IIB05-1-S

## INSTALLATION BULLETIN

**SUBJECT:** Home Standby Air-cooled Generators - Serial Numbers 3789827 and Below

**Figure 2**

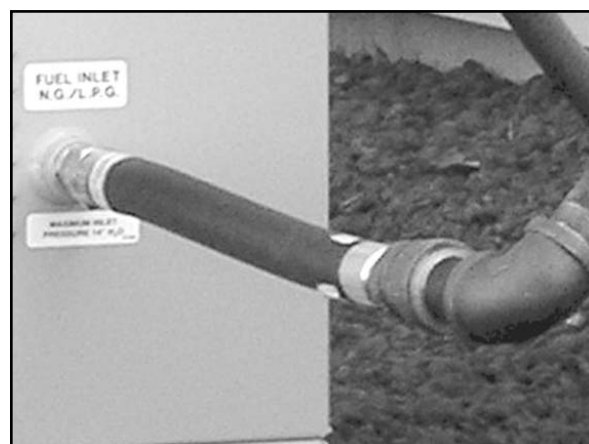
**CAUTION:** The 12" braided flex fuel line supplied with the subject generators can leak if improperly installed.

The flex fuel line must not be bent beyond 10 degrees during the installation and upon completion of installation. Replace the fuel line if bent or if ferrules are damaged. The replacement fuel line is Part # 0D3031A. Ensure the installation of the new fuel line eliminates bends.

Proper Installation Of New Flex Fuel Line Without Bends
